FILE: 1408507-BMI-4443-CU101 Adend.dwg
 UPDATE BY: Chrls Groth
 PLOT DATE: 7/20/2015 11:09 AM

BLOOMINGTON-NORMAL AIRPORT AUTHORITY
CENTRAL ILLINOIS REGIONAL AIRPORT
BLOOMINGTON, ILLINOIS
RECONSTRUCT AIRPORT SERVICE ROAD
DRAINAGE PLAN SHEET 1

FILE: 1408507-BMI-4443-CU102 Amend.dwg
 UPDATE BY: Chris Groth
 PLOT DATE: 7/20/2015 11:21 AM

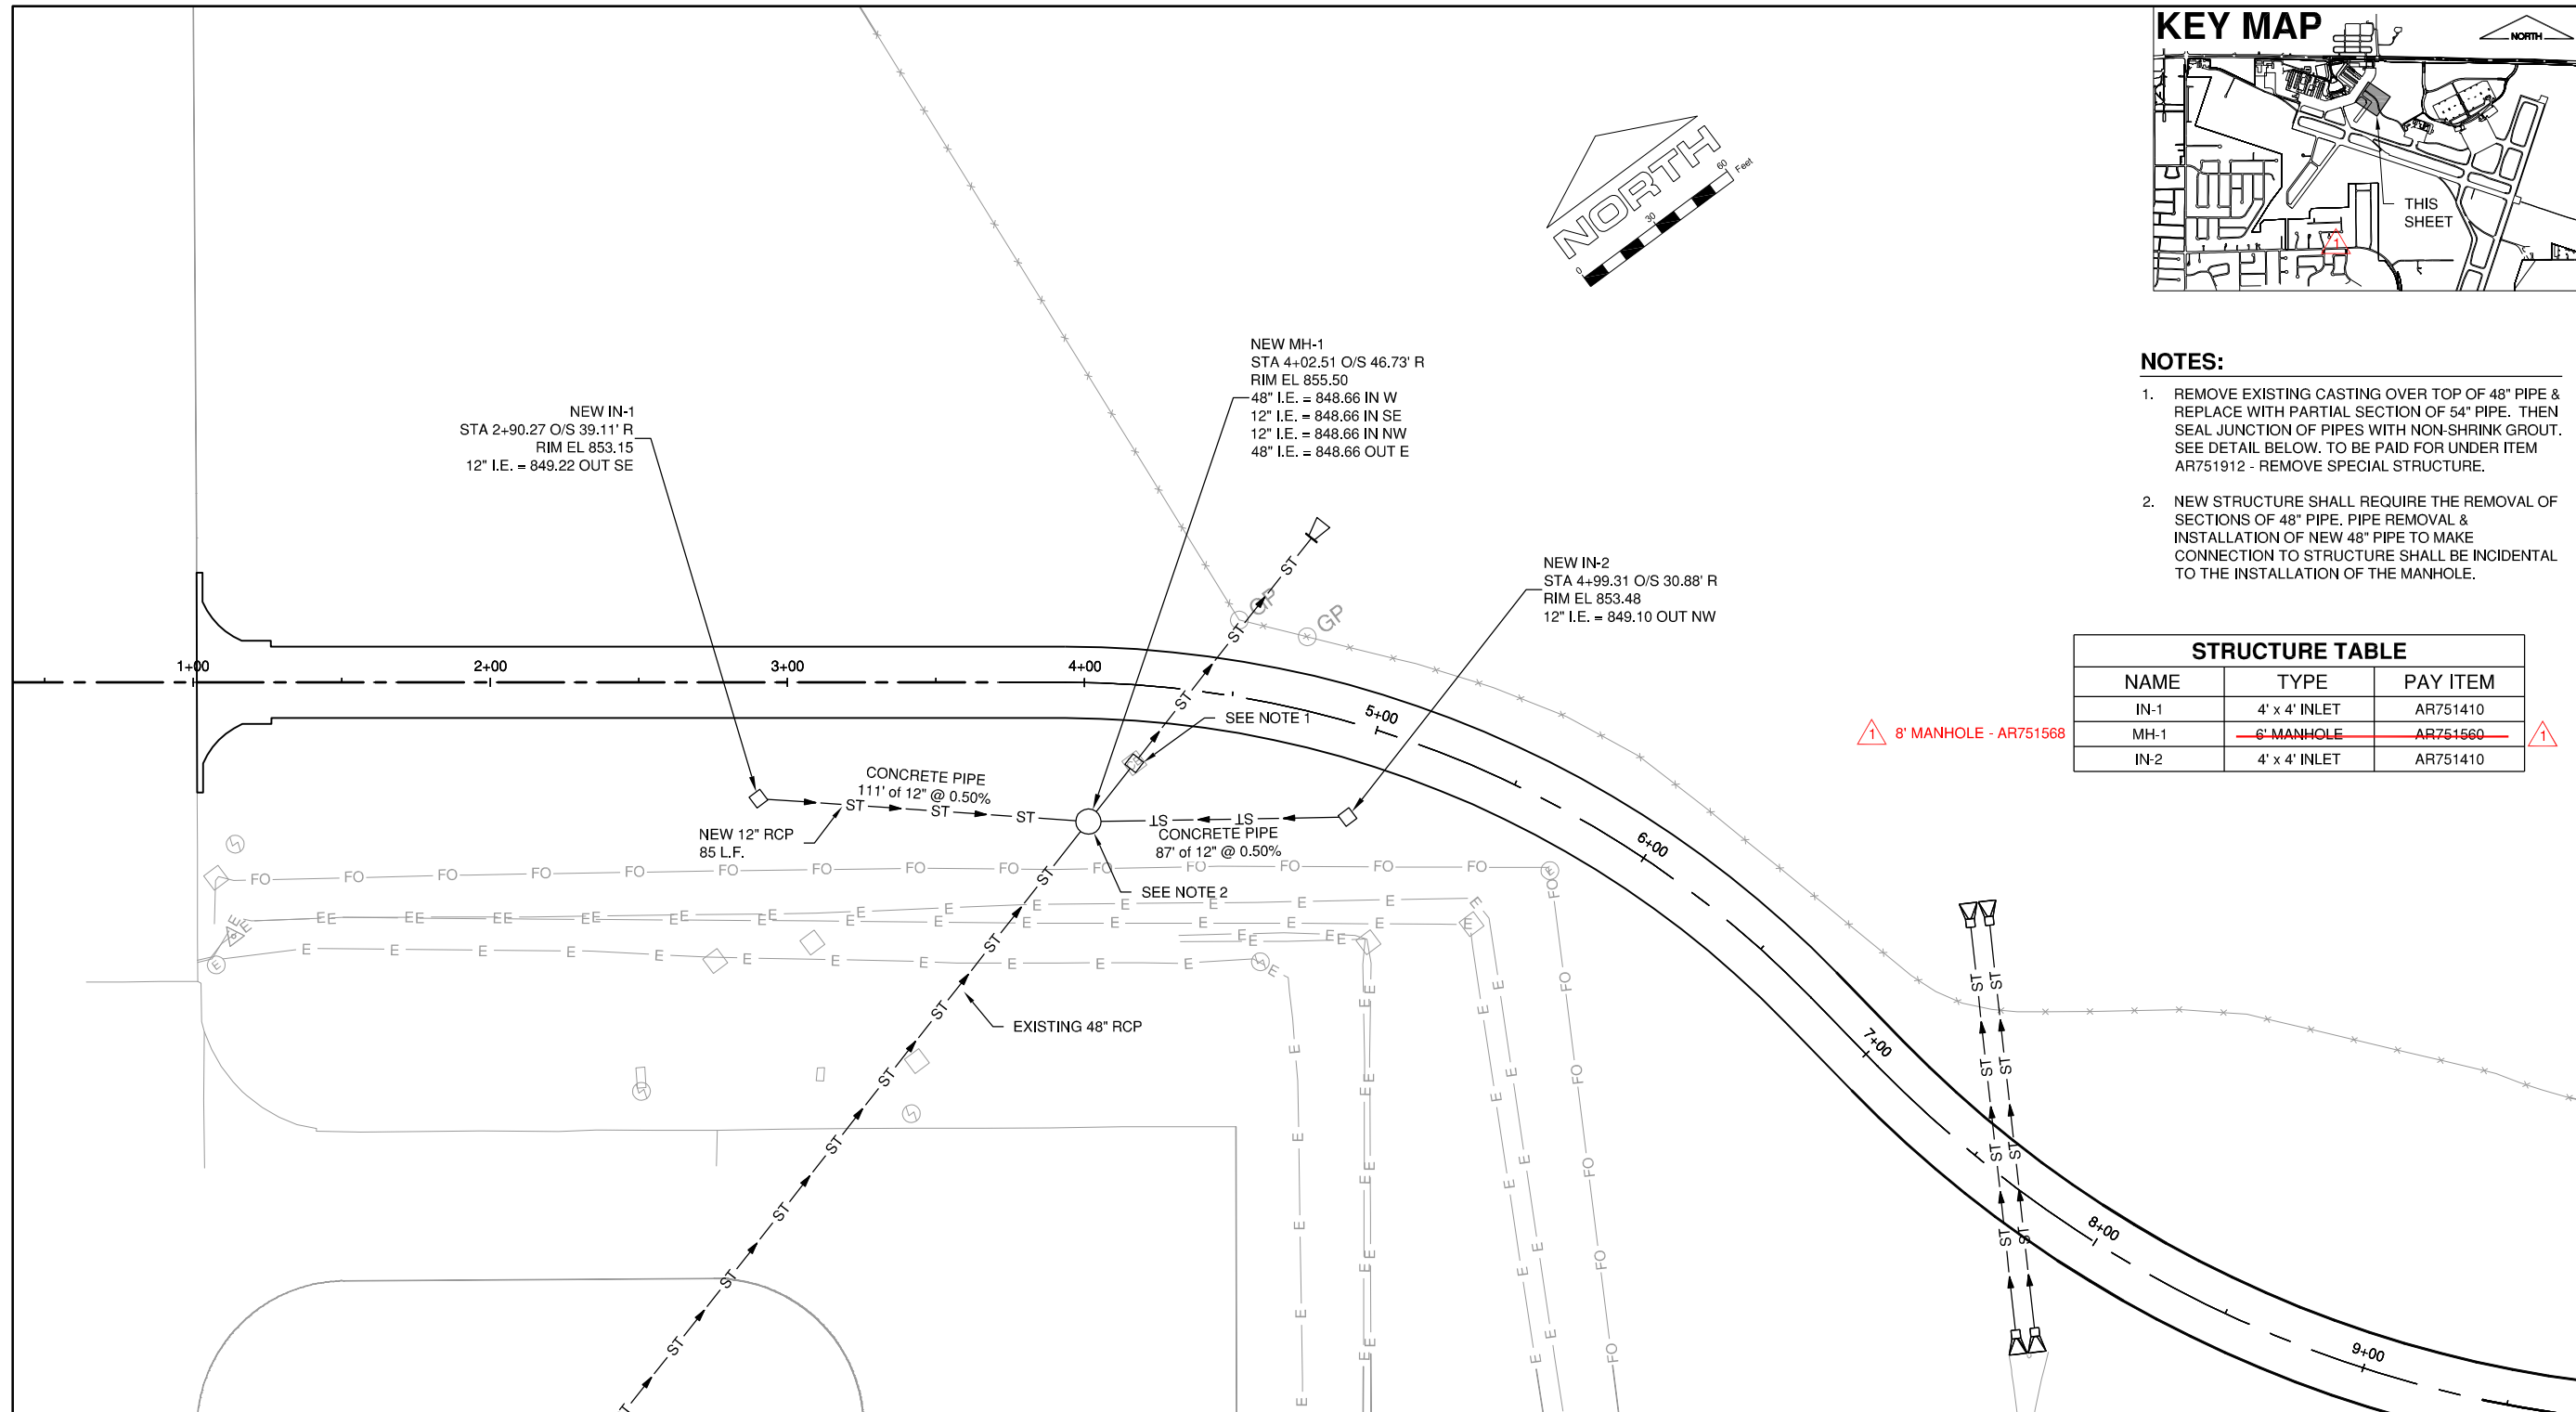
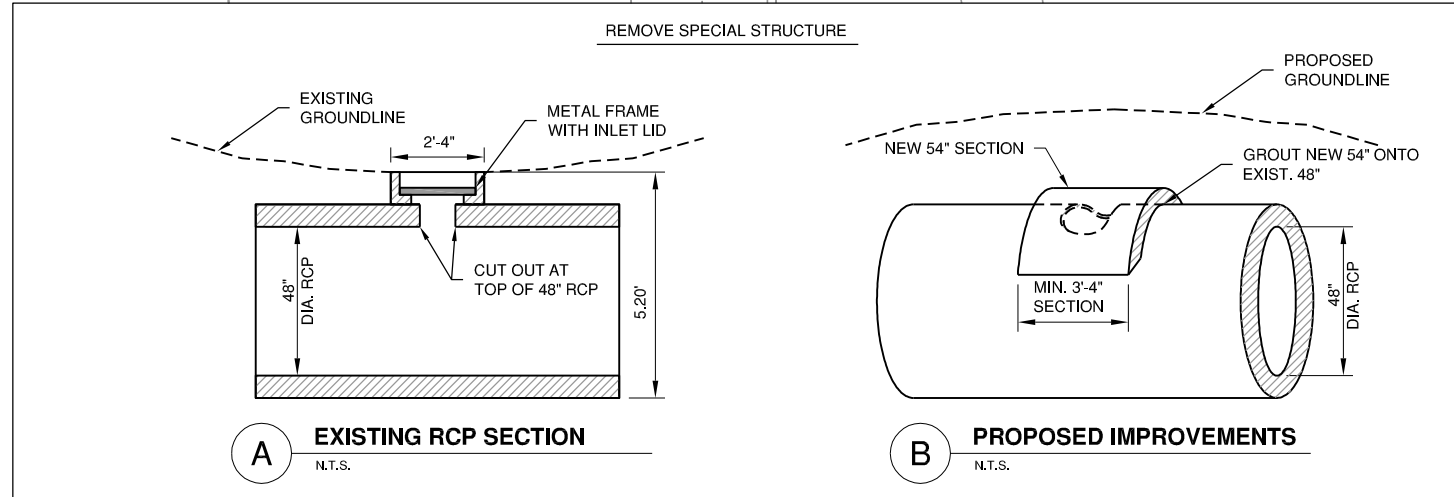
- REMOVE EXISTING CASTING OVER TOP OF 48" PIPE & REPLACE WITH PARTIAL SECTION OF 54" PIPE. THEN SEAL JUNCTION OF PIPES WITH NON-SHRINK GROUT. SEE DETAIL BELOW. TO BE PAID FOR UNDER ITEM AR751912 - REMOVE SPECIAL STRUCTURE.
- NEW STRUCTURE SHALL REQUIRE THE REMOVAL OF SECTIONS OF 48" PIPE. PIPE REMOVAL & INSTALLATION OF NEW 48" PIPE TO MAKE CONNECTION TO STRUCTURE SHALL BE INCIDENTAL TO THE INSTALLATION OF THE MANHOLE.
